# CITY OF ALBUQUERQUE

**Re: Starbucks**  
**2004 Wyoming Blvd. NE**  
**Traffic Circulation Layout**  
Engineer's Stamp 05-09-23 (H20-D003E)

Based upon the information provided in your submittal received 05-11-23, the above referenced plan cannot be approved for Building Permit until the following comments are addressed:

SHEET NUMBER  
C4.0

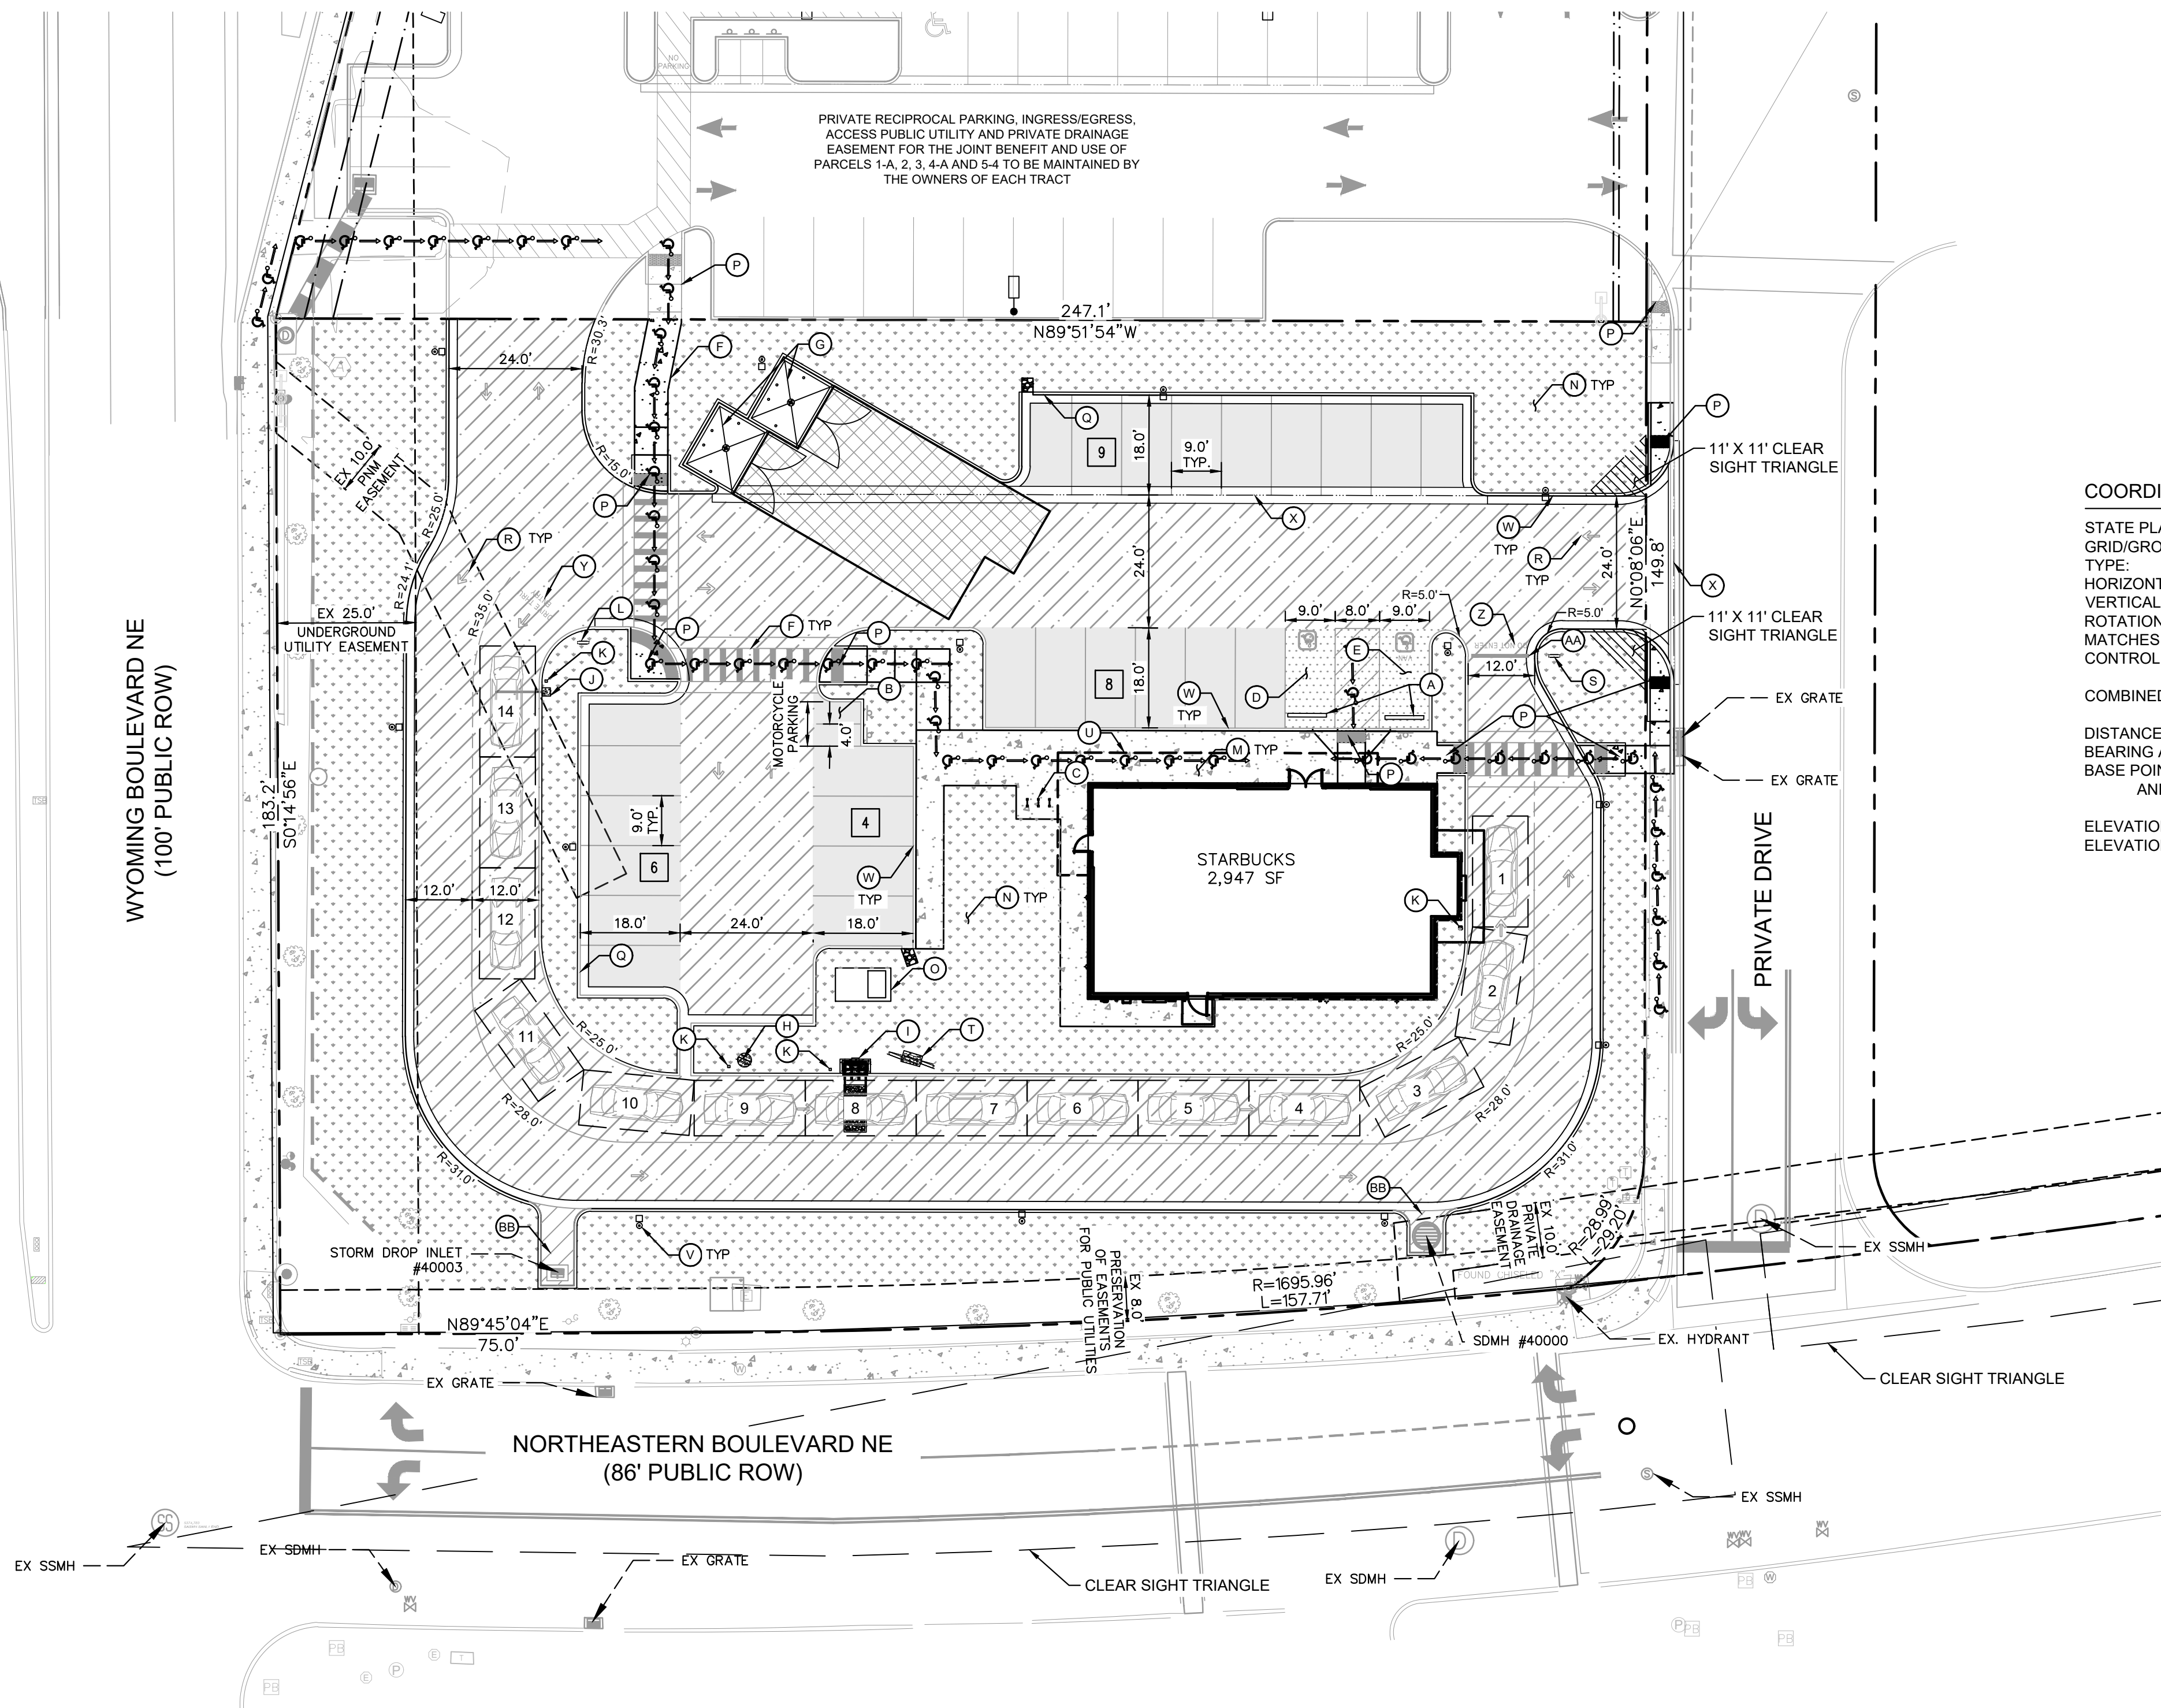
1. Identify all existing access easements and rights of way width dimensions.
2. PLEASE PROVIDE COPY OF Approved plat.
3. Show on the site plan site access radius.

4. ADA curb ramp at the corner of Wyoming Blvd. & Northeastern Blvd. must be updated to current standards and have truncated domes installed.
5. ADA curb ramp at the corner of Northeastern Blvd. and the Private Drive must be updated to current standards and have truncated domes installed.
6. The pavement marking "MC" should be shown in the opposite direction for motorcycles entering the parking space.
7. All bicycle racks shall be designed according to the following guidelines:
  - a. The rack shall be a minimum 30 inches tall and 18 inches wide.
  - b. The bicycle frame shall be supported horizontally at two or more places. Comb/toaster racks are not allowed.
  - c. The rack shall be designed to support the bicycle in an upright position. See the IDO for additional information.

- d. The rack allows varying bicycle frame sizes and styles to be attached.
- e. The user is not required to lift the bicycle onto the bicycle rack.
- f. Each bicycle parking space is accessible without moving another bicycle.
8. Bicycle racks shall be sturdy and anchored to a concrete pad.
9. A 1-foot clear zone around the bicycle parking stall shall be provided.
10. Bicycle parking spaces shall be at least 6 feet long and 2 feet wide.
11. Please show on the site plan the ADA Pedestrian pathway width.
12. Please show this dimension on the site plan.

13. The ADA access aisles shall have the words **"NO PARKING"** in capital letters, each of which shall be at least one foot high and at least two inches wide, placed at the rear of the parking space so as to be close to where an adjacent vehicle's rear tire would be placed. (66-1-4.1. B NMSA 1978).
14. ADA details on sheet C4.2 do not match ADA parking spaces on sheet C4.0.
